TECHNICAL MEMORANDUM

Utah Coal Regulatory Program

RE: Dugout Canyon Mine, 560-Acre Extension, Canyon Fuel Company, LLC, C/007/0039, Task ID #2958

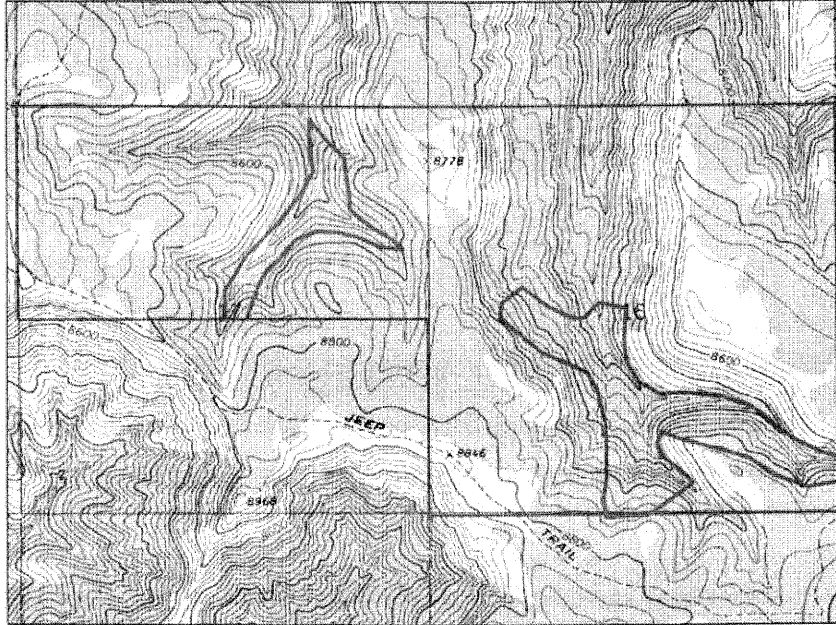
The mature conifer/quaking aspen stand in Sections 16 and 17 (refer to map below; Tony Wright DWR email 12192007) will be undermined in years 2010 and 2011.

The Permittee does not provide information concerning this expansion action and these two stands. The Division considers that the Permittee must provide a protection or mitigation plan for possible tree-nesting raptors that may be impacted by subsidence (R645-301-332, -333).
